PLANNING AND DEVELOPMENT SERVICES STAFF REPORT

For Planning Commission Meeting of April 7, 2015

**SUBJECT: Staybridge Suites & Retail Rezoning and Planned Project Site Plan
File Nos. SP14-057 & Z14-028**

SHEET TITLE:
SITE LAYOUT AND PAVING PLAN

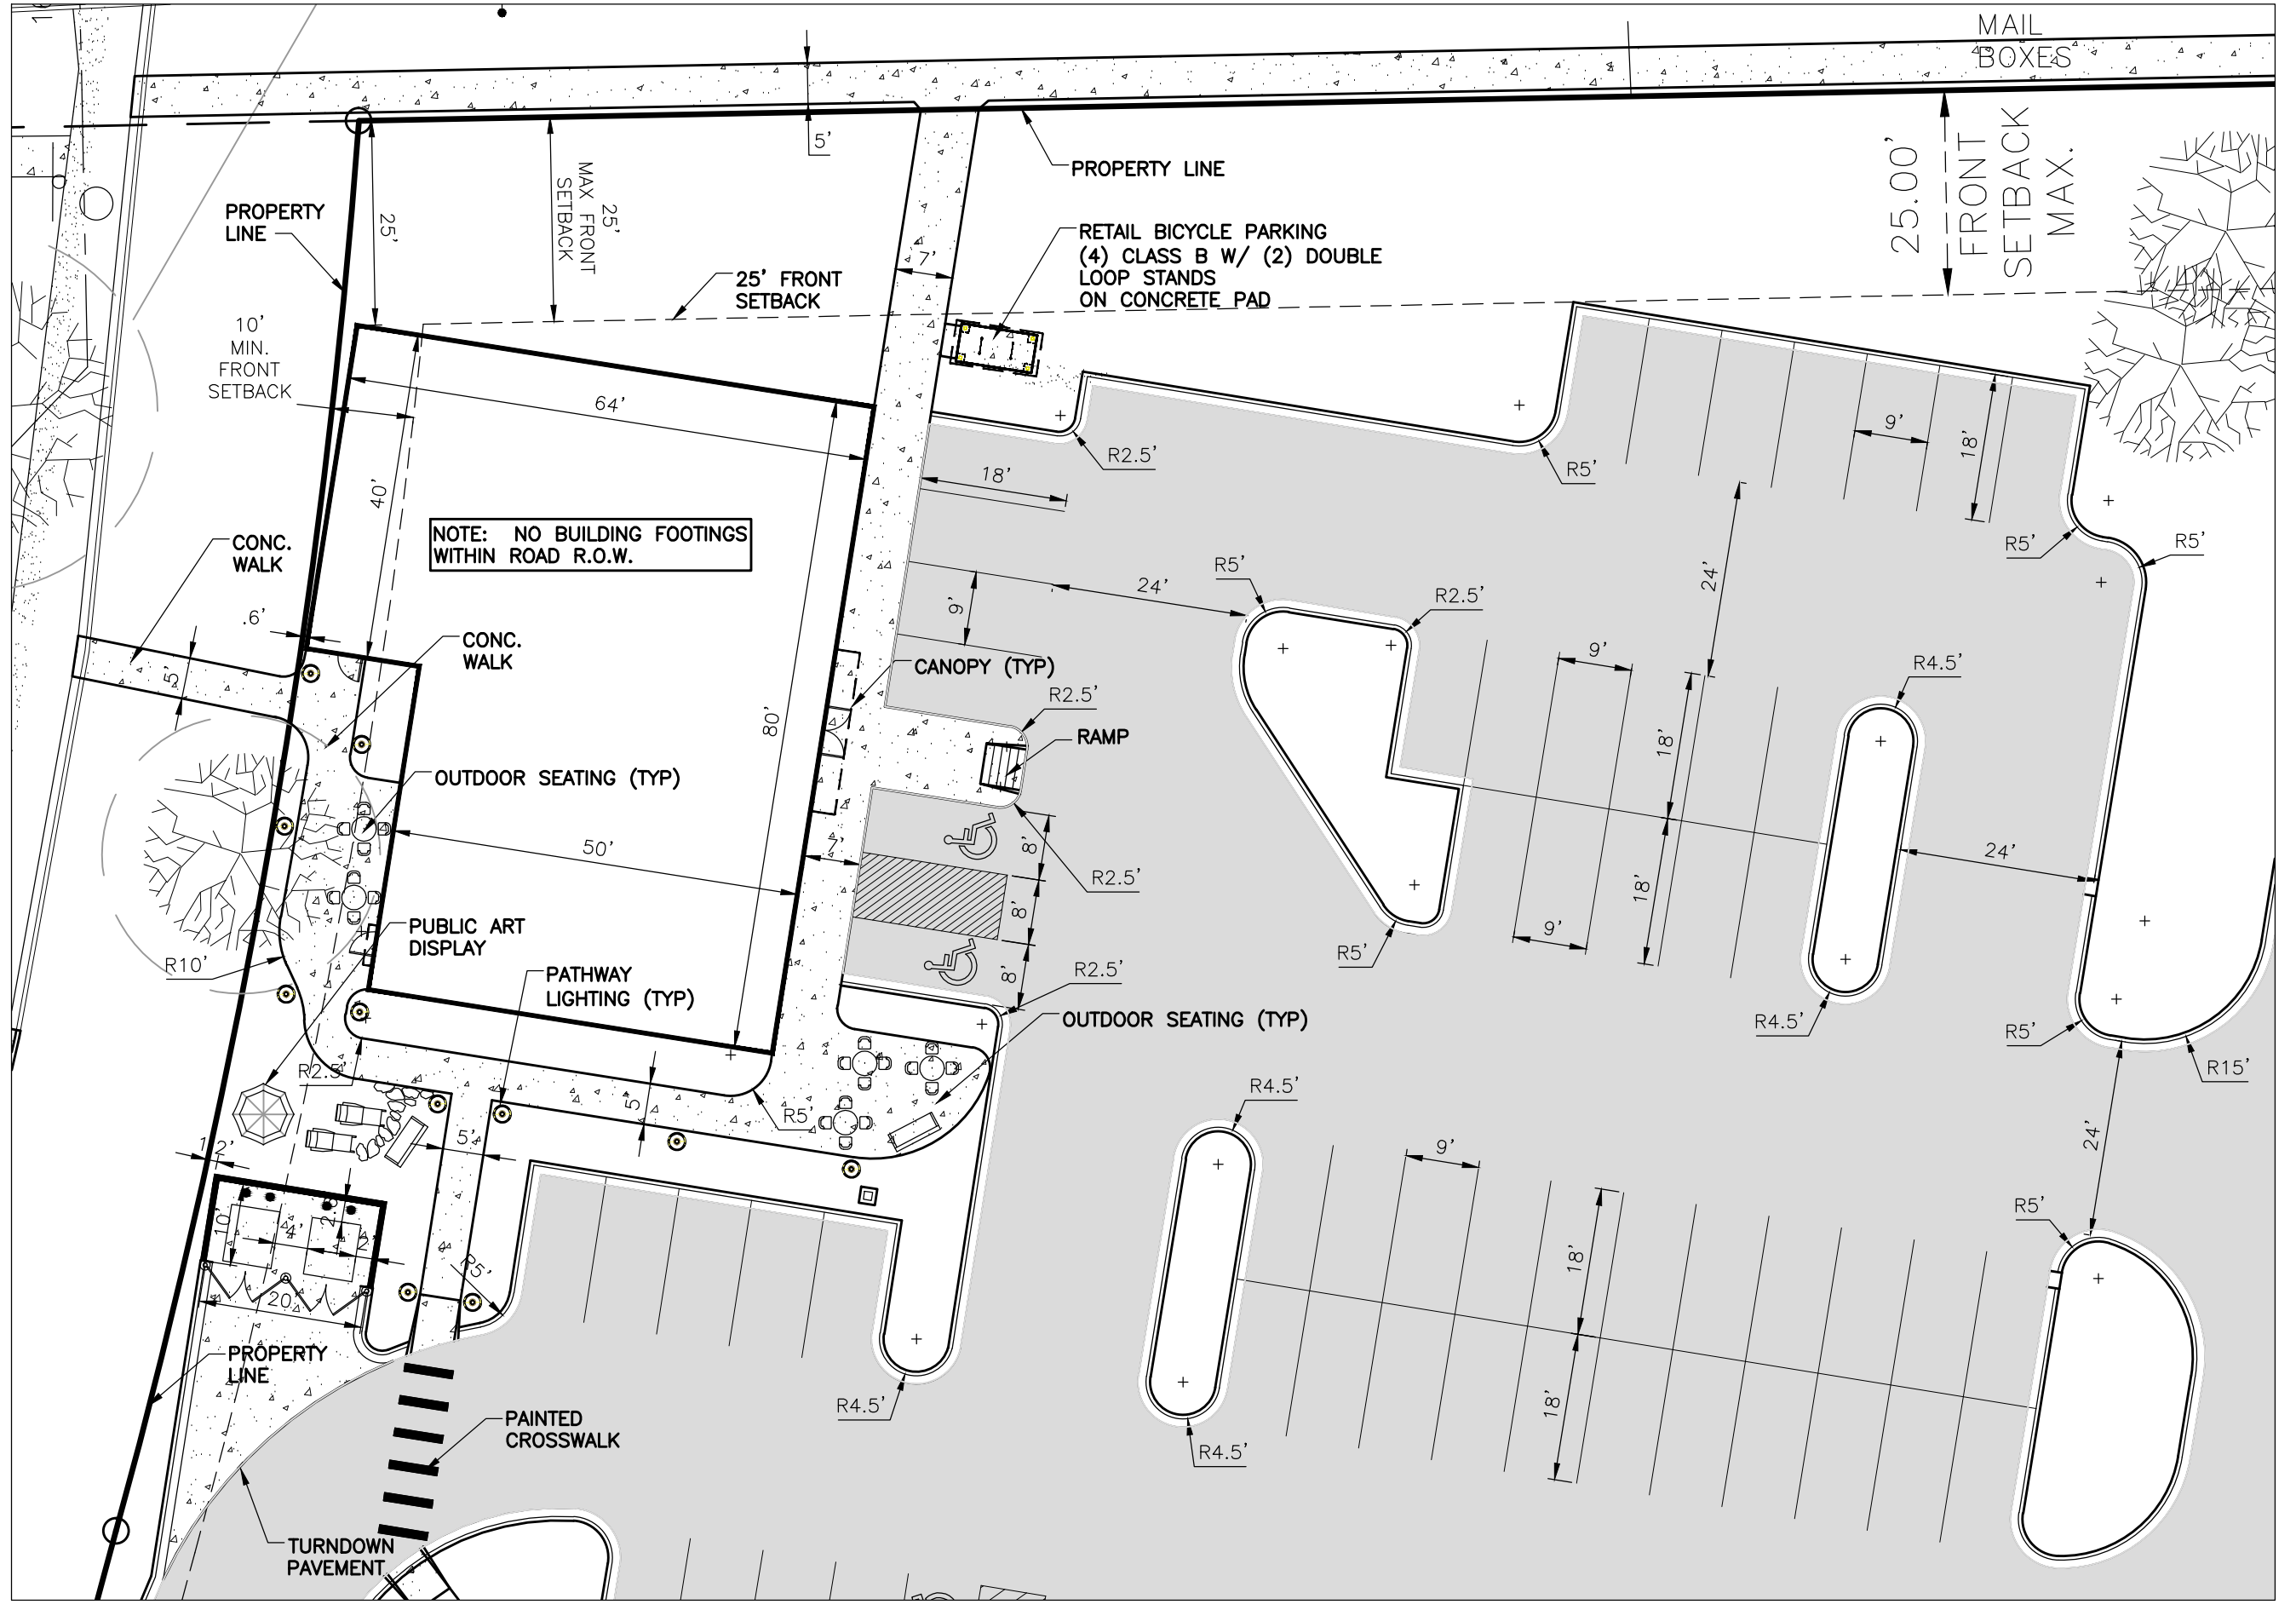
A planned project modification is requested to reduce the front setback along South State Street for the proposed retail building from the minimum requirement of 10 feet to approximately 0.5

feet. This reduced front setback places the building 55 feet from the South State Street right-of-way and approximately 85 feet from the east curb line of the road due to a wide right-of-way.

SCALE: 1"=40'
JOB NO.: BD-14-322
SHEET TITLE: LANDSCAPE PLAN AND DETAILS

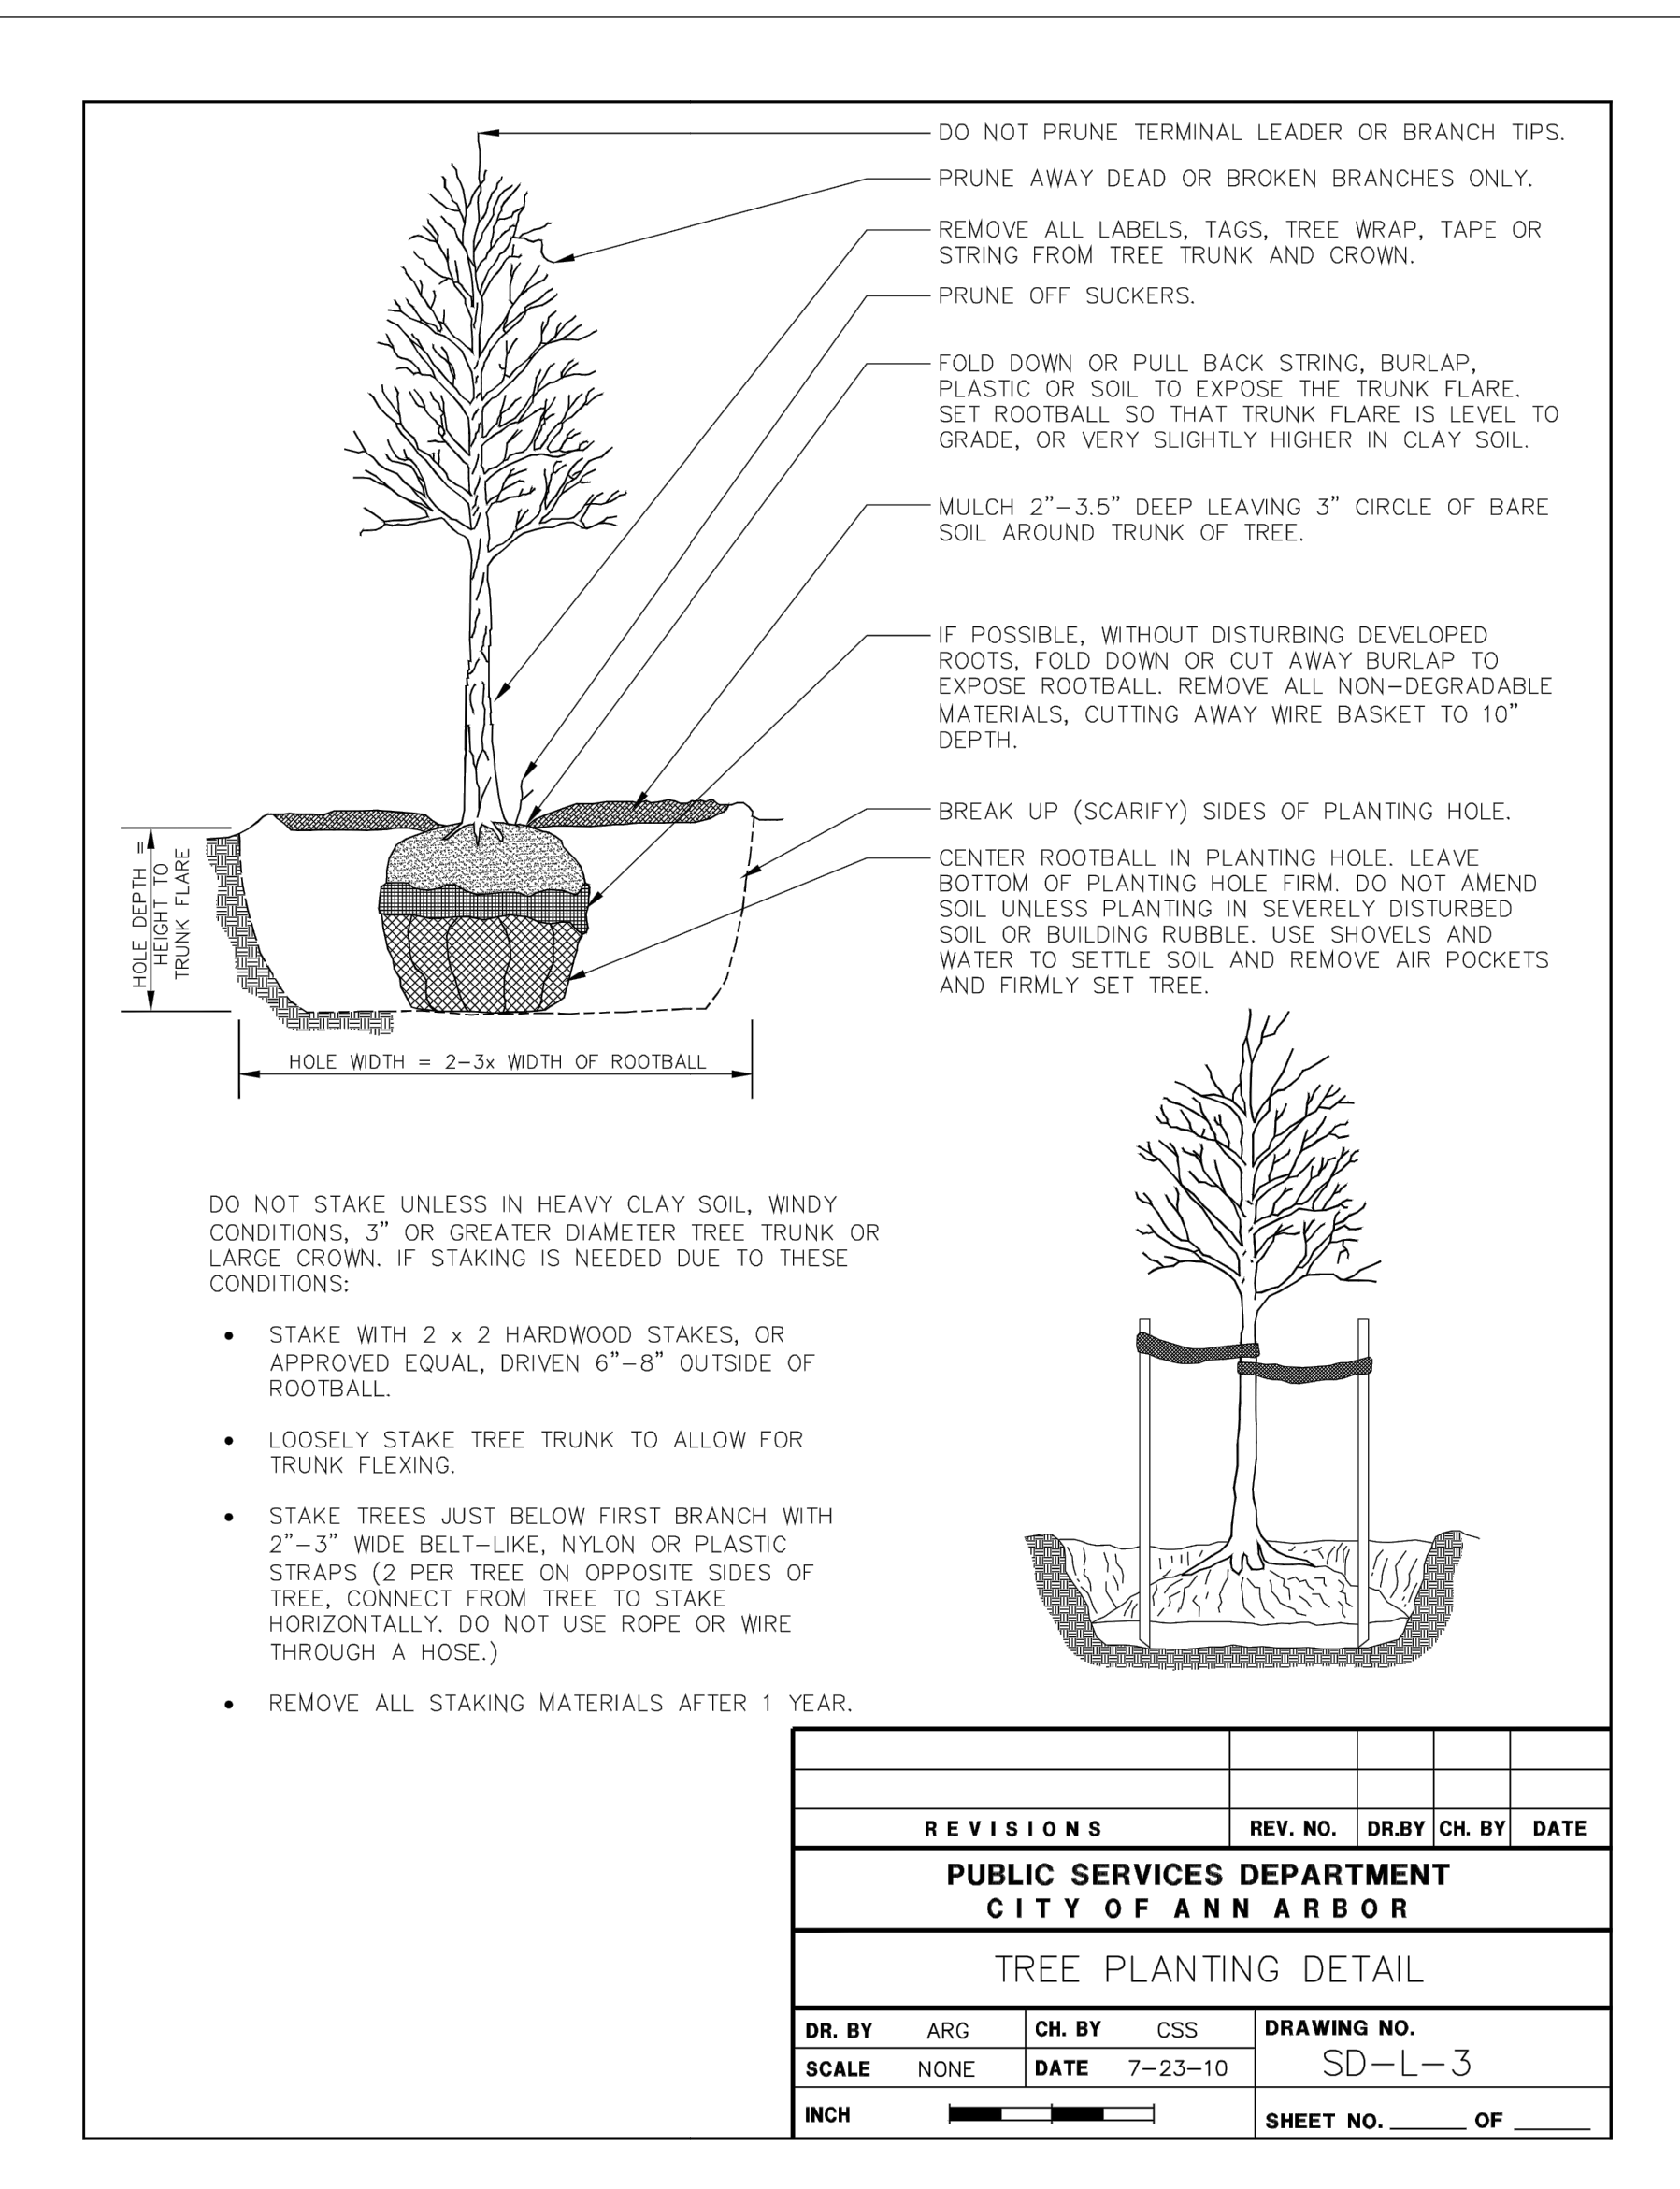
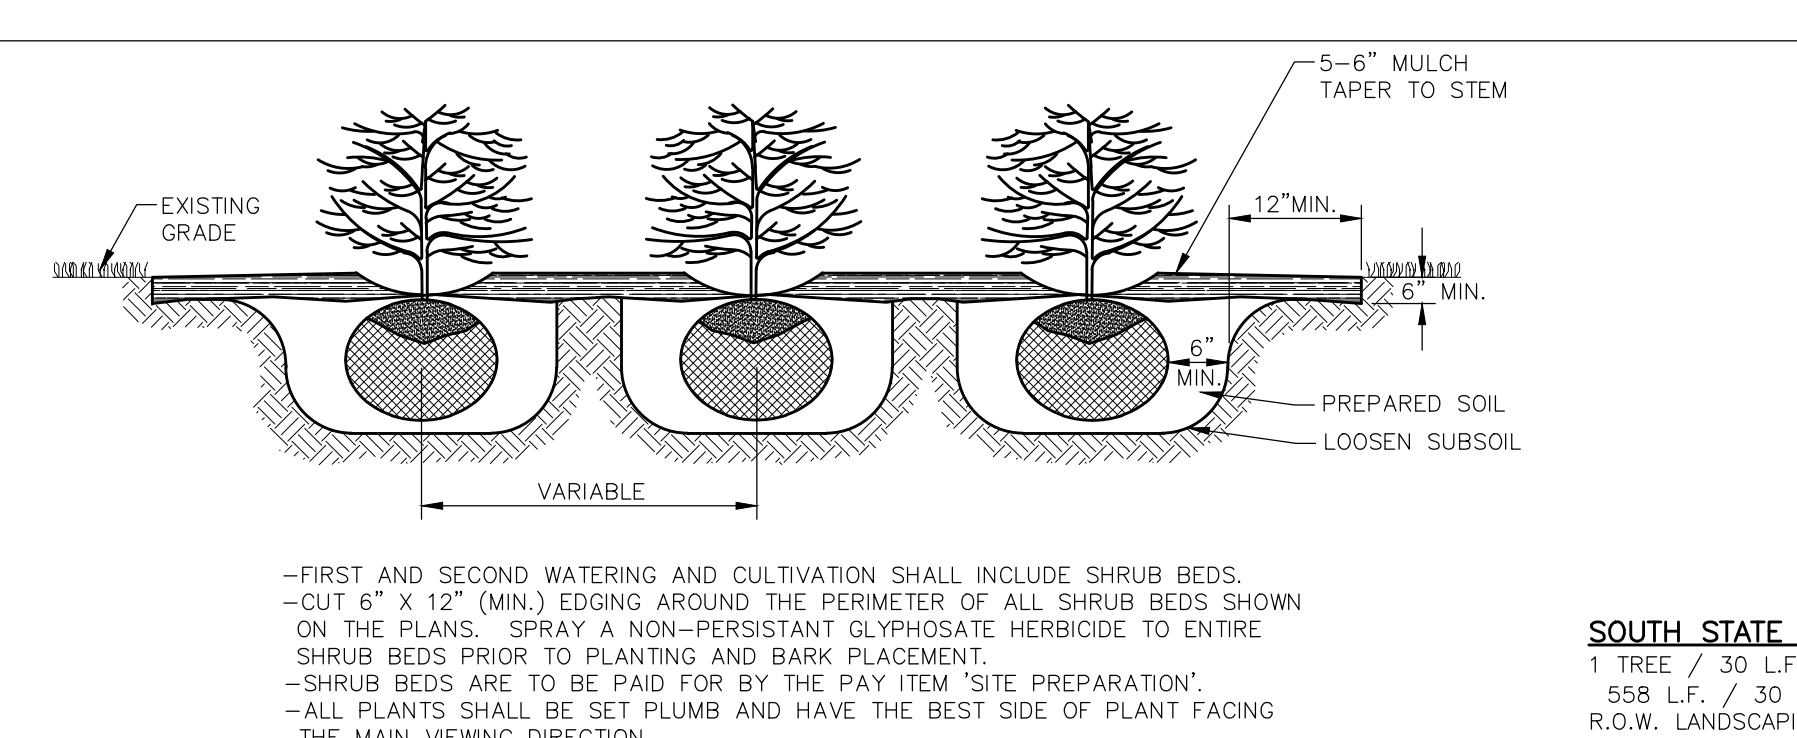
Urban Forestry – The site layout shows encroachment into the critical root zone of the landmark trees (#2417, 2418, 2419, 2420 and 2425). Encroachment into the critical root zone of the landmark trees is not permitted without City approval at the time of site plan approval. Staff does not support encroachment into the critical root zone of these trees. The current encroachment shown is less than 5 feet, which does not take into consideration the encroachment that will occur for the construction of the curb which will move the encroachment to less than 2 feet from the trunk. Please revise drawings to remove encroachment from the critical root zone of these trees.

A hedge, dense shrub planting, landform berm, wall or combination is required in the right-of-way screening of the vehicular use area. This screening is required along S. State Street and has not been shown on the landscape plan. If adherence to this standard will damage the landmark trees in this area, a Landscape Modification may be submitted.
